Traffic Systems Design Directive

169 Brick Store Landing Road, Smyrna, DE

Number (Year - #) 2017-2

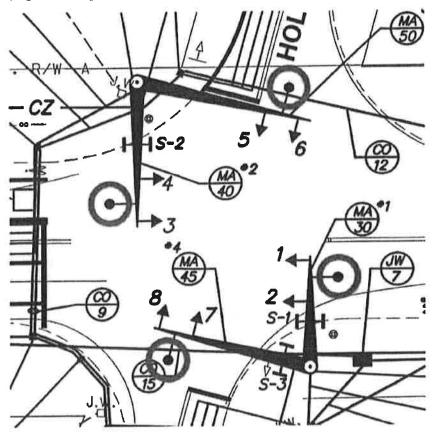
[...] Signal preemption detectors should be designed and installed on all approaches of DelDOT owned and maintained signals. The optical detectors should face "outside the box" – i.e., typically nearside closest to the stop line and facing approaching traffic (see enclosed figure).

When installed nearside and facing outward/upstream, optical reflection interference from adjacent overhead signs, signal housings, backplates, etc. can generally be minimized.
